Product Change Notice (PCN)

PCN Number: **PCN-0451050R-01**

Product(s) Affected: **PJ-019**

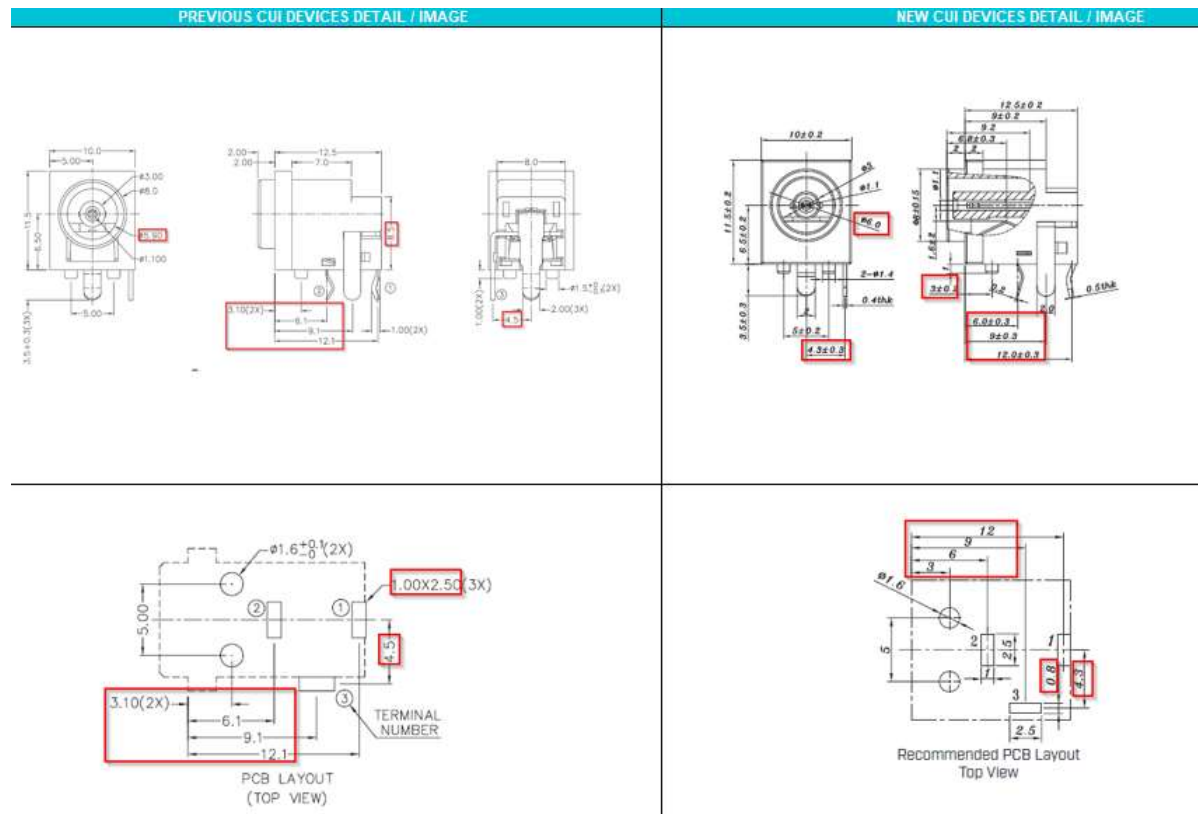
Description of Change: **Mechanical, electrical, and material changes as shown below:**

| | MATERIAL | PLATING |
| center pin | brass | tin |
| terminal 1 | brass | tin |
| terminal 2 | copper alloy | tin |
| terminal 3 | brass | tin |
| plastic | PBT | |

| DESCRIPTION | MATERIAL | PLATING/COLOR |
| terminal 1 | phosphor bronze | silver |
| terminal 2 | SUS | silver |
| terminal 3 | brass | silver |
| housing | PBT (UL94V-0) | black |
